CALIFORNIA COASTAL COMMISSION

**RECORD PACKET COPY****Tu 9a****PROPOSED FINDINGS****ON CONSISTENCY DETERMINATION**Consistency Determination No. **CD-117-99**

FEDERAL AGENCY: CORPS OF ENGINEERS**DEVELOPMENT****LOCATION:** Lower Mission Creek, Santa Barbara (Exhibit 1)**DEVELOPMENT****DESCRIPTION:** Lower Mission Creek flood-control improvements
(Exhibits 2-9)**PREVAILING****COMMISSIONERS:** Commissioners Dettloff, Allgood, Hart, Lee, McCoy,
Nava, Woolley, and Chairperson Wan**EXECUTIVE SUMMARY**

Rendering of short floodwalls with vegetated riprap¹

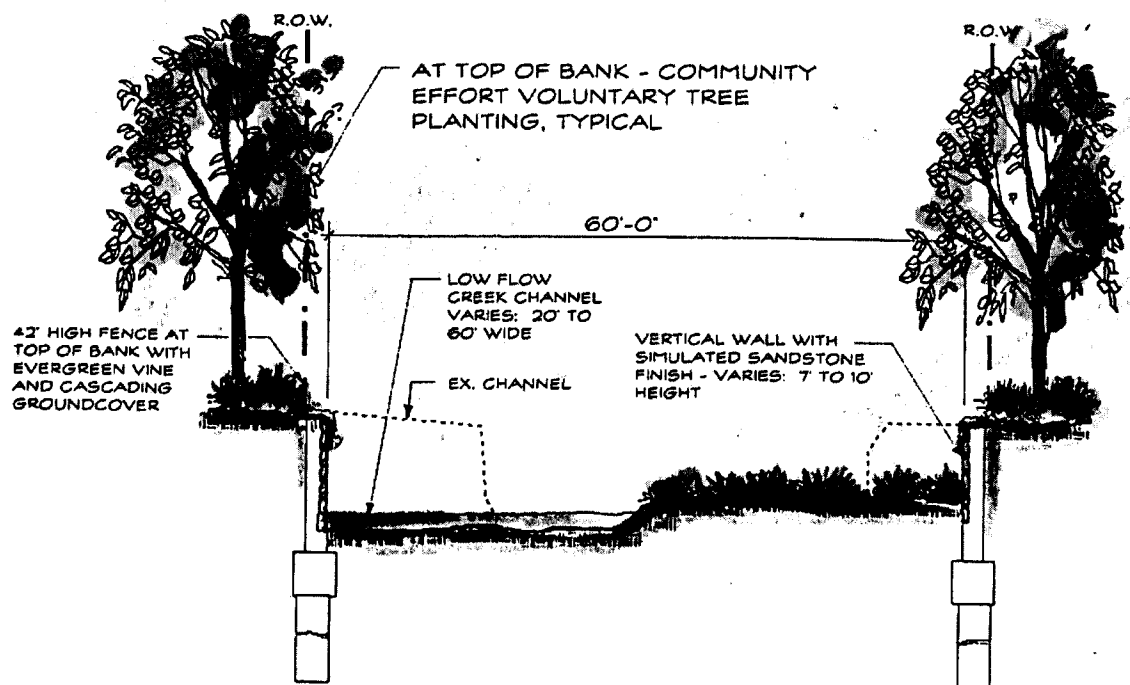
The proposed construction of the vertical walls south of Highway 101 could adversely affect visual resources of the coastal zone. Section 30251 of the Coastal Act provides for the protection of visual resources within the coastal zone. In its environmental documents, the Corps proposes to design the project in a manner that minimizes visual impacts. This commitment will be confirmed through federal consistency review of the final design plans.

The creek banks will consist of either a vertical wall or a combination vertical wall and riprap sideslope. The combination bank treatment will consist of vertical wall for the bottom half, while ungrouted riprap (15 inches thick) at a 1.5:1 (Vertical to Height ratio) slope will form the upper half. The height of the vertical wall in this

EXHIBIT 1
42' LMC July Noon
@ 5 to 10 Years

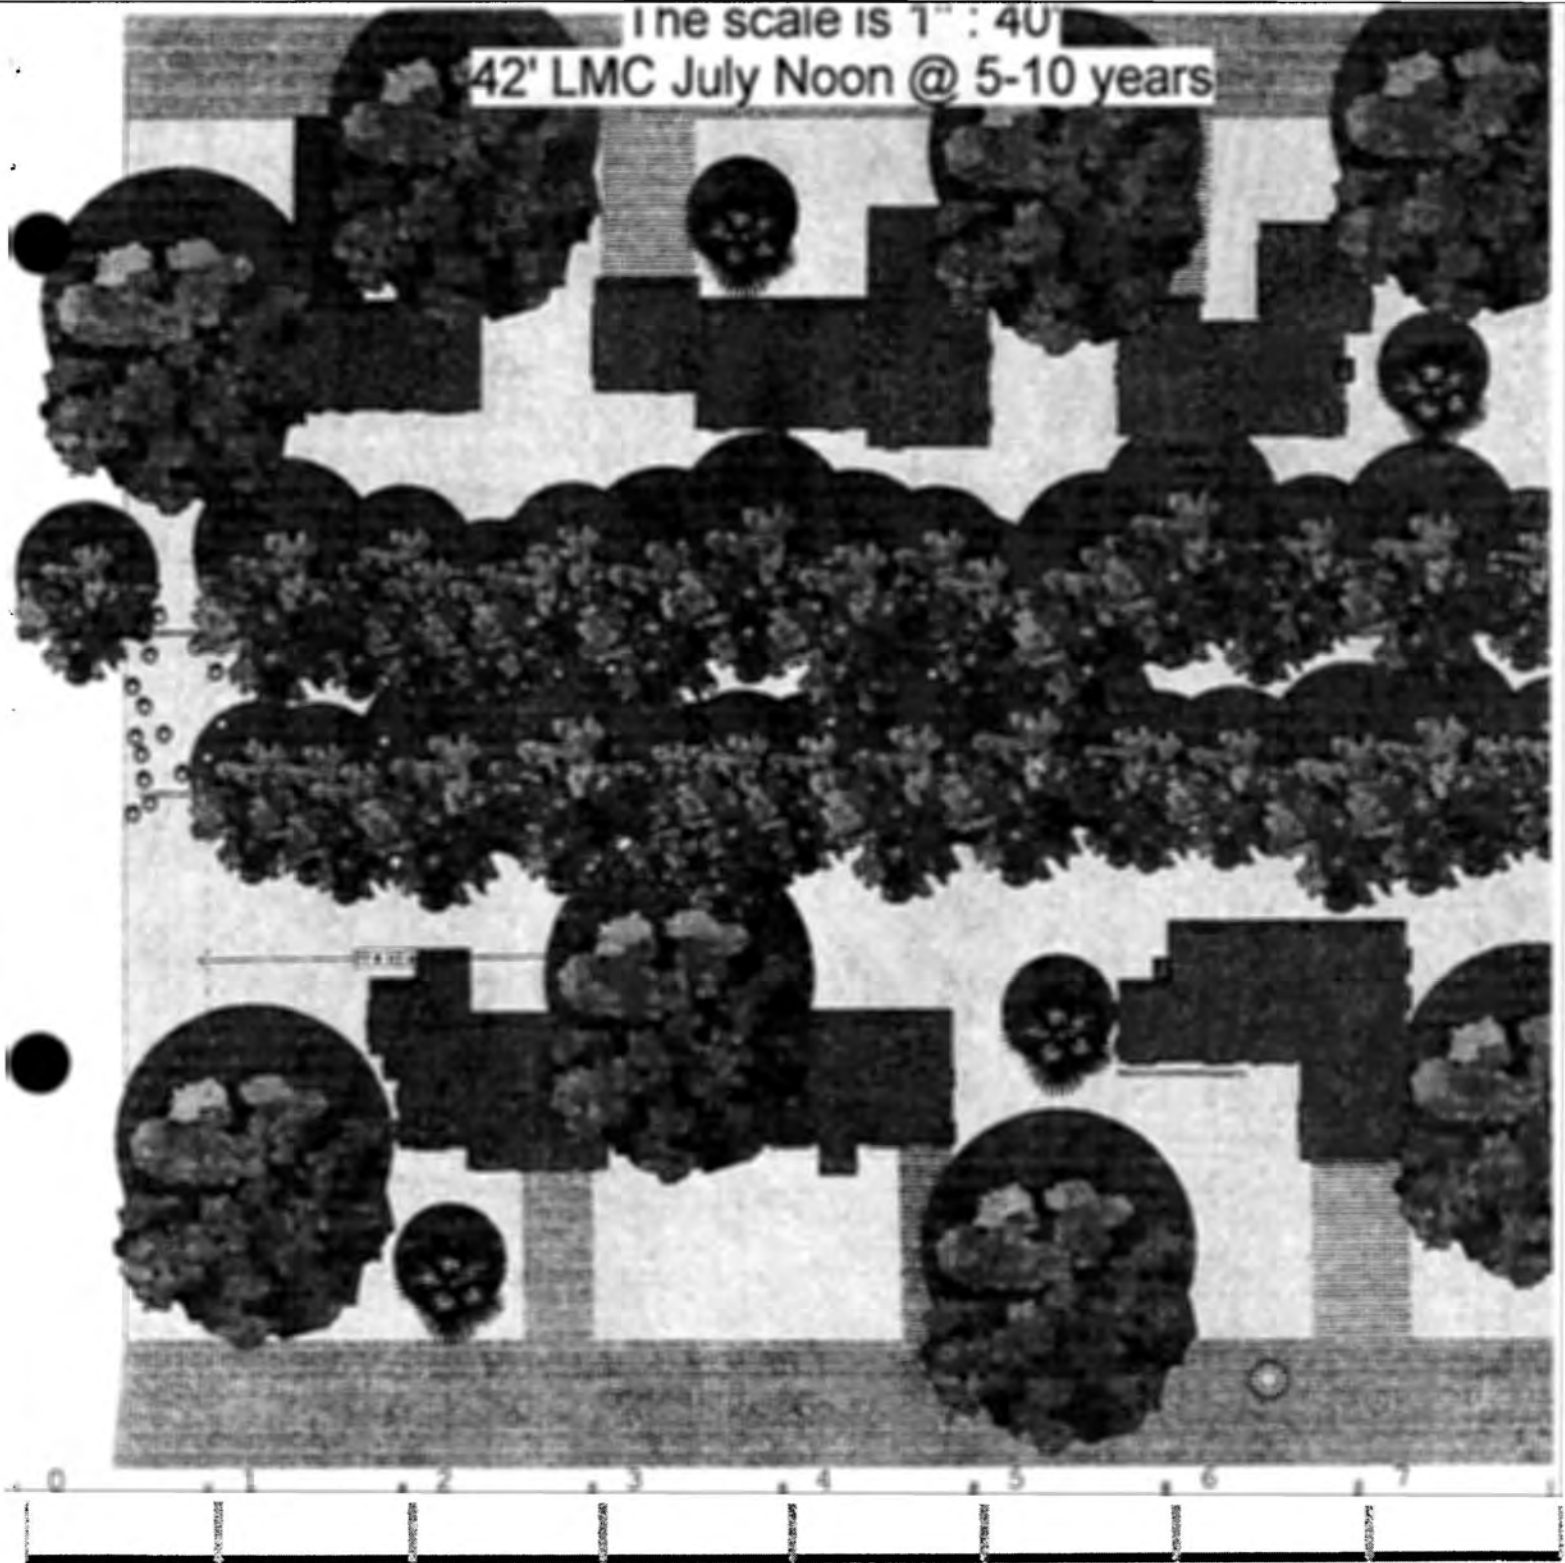
For the section above the freeway, a plan view is attached as Exhibit 1. The plan view is for trees that have grown 5 to 10 years. The view shows the extent of shade produced by these trees in July. Also provided are two 3-D pictures showing the size of the trees in 5 to 10 years (Exhibit 2) and the trees in 20 to 30 years (Exhibit 3). This analysis clearly indicates that the proposed planting of sycamore and willow trees will completely shade

EXHIBIT 10
 Existing LMC Feb. Noon
 (Cabrillo to Chapala)

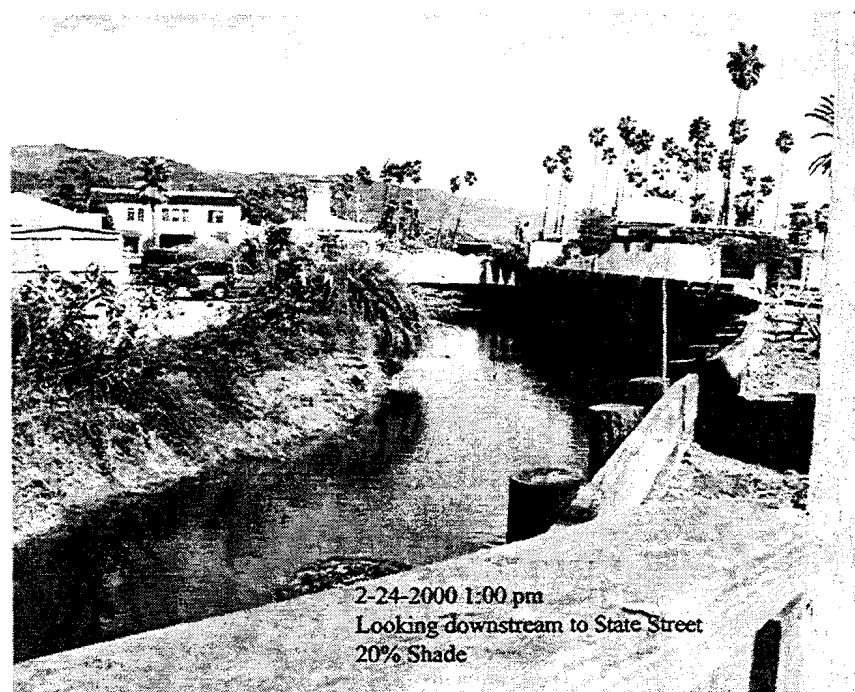
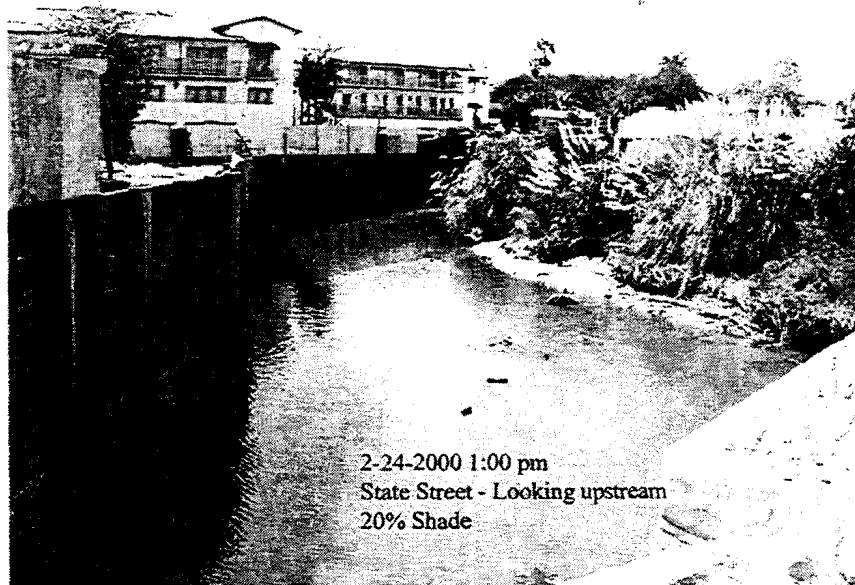
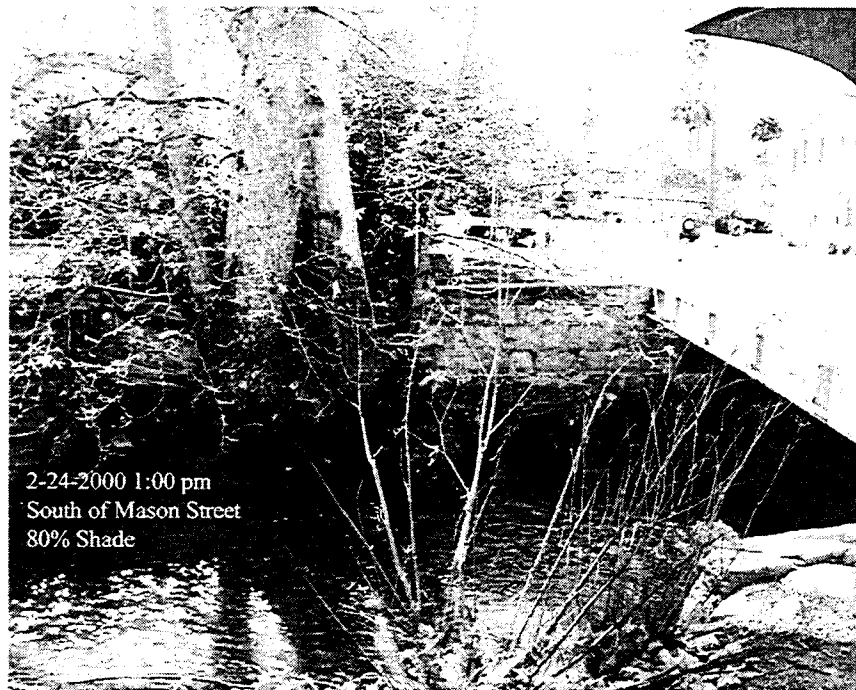
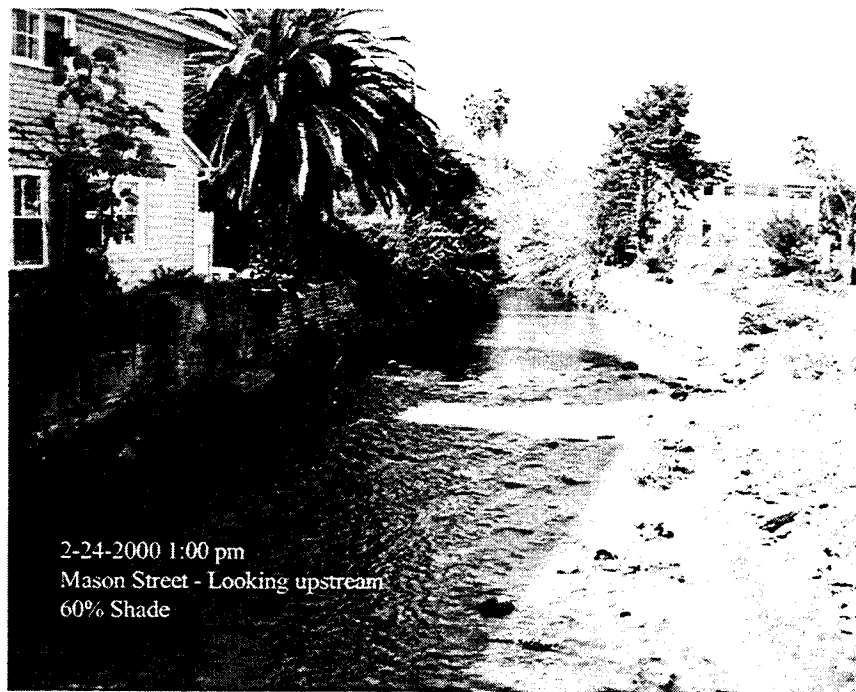
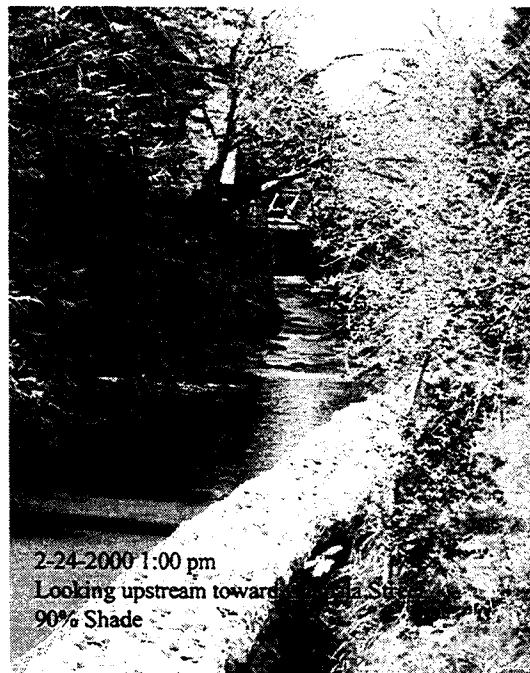
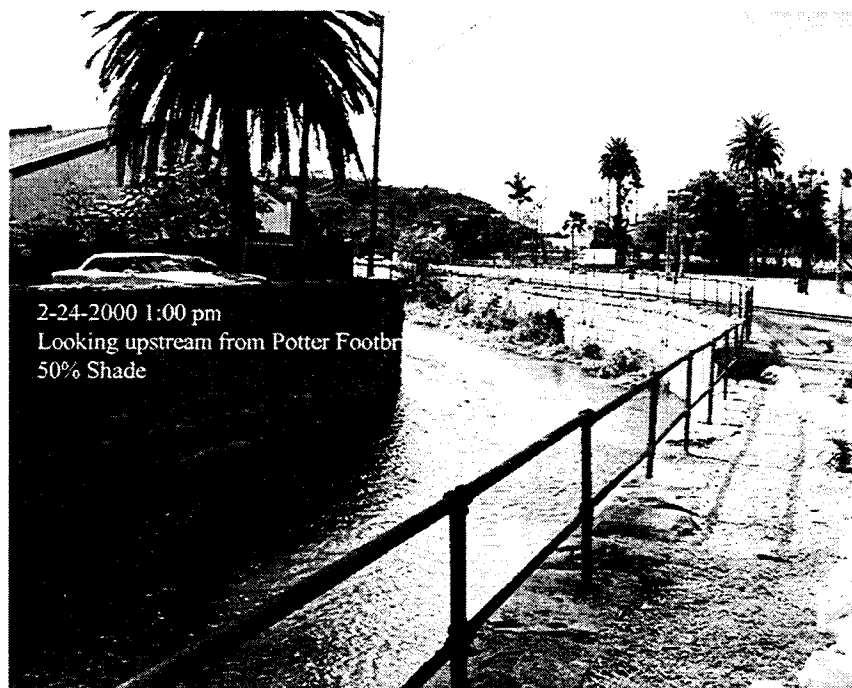
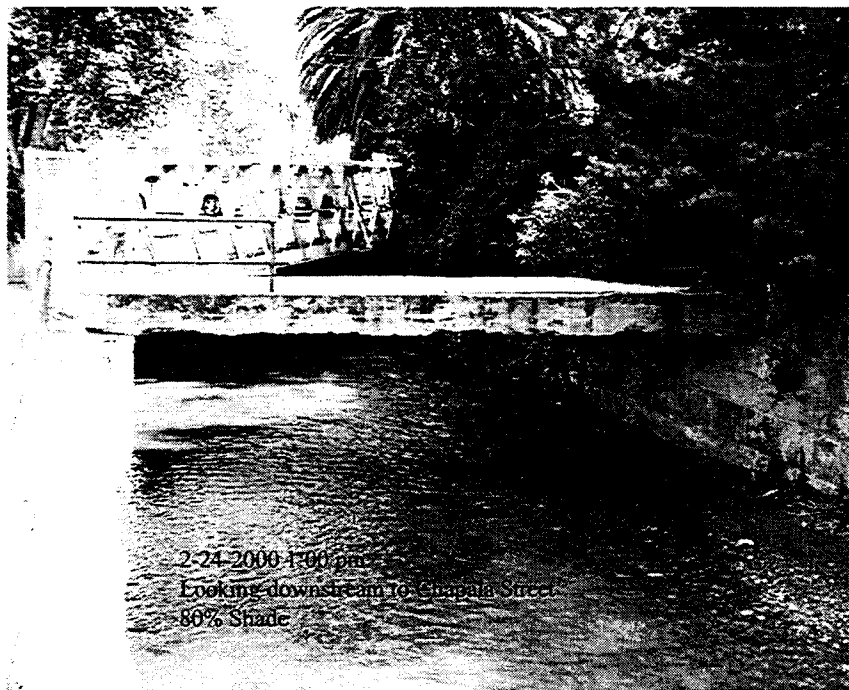
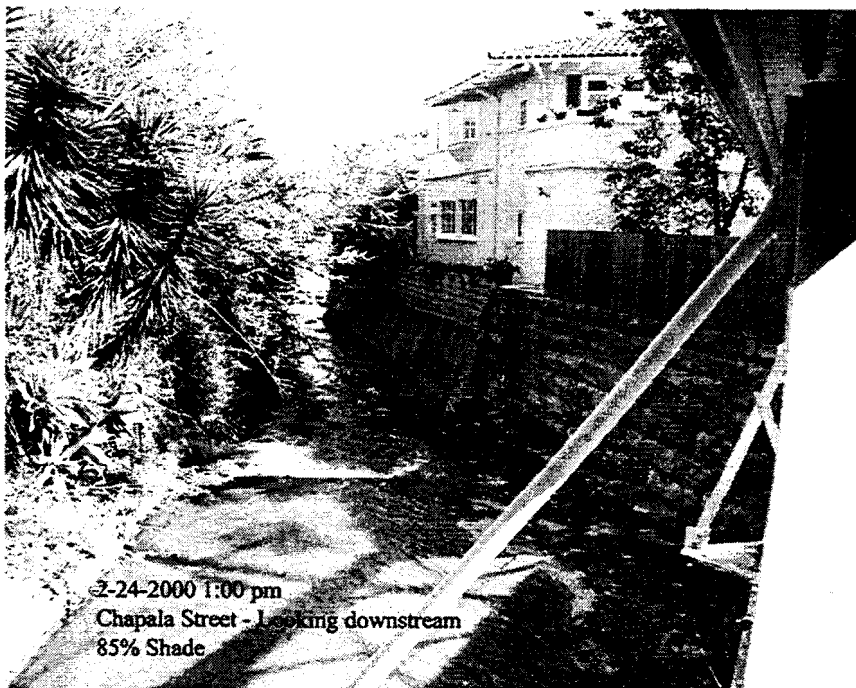
Existing shade conditions can be seen in the 14 photos included in Exhibit 10. These photos show that the only shade on the creek from Cabrillo to almost Mason Street, is from the walls, buildings and bushes along the creek. The planting of fast-growing riparian sycamore trees would quickly add shade to this section of creek. This shade would increase over time as shown in Exhibits 4 through 9. The section of creek at Mason Street is currently well shaded by the giant sycamore tree just downstream of the Mason Street Bridge. The project as currently proposed includes preservation of this tree
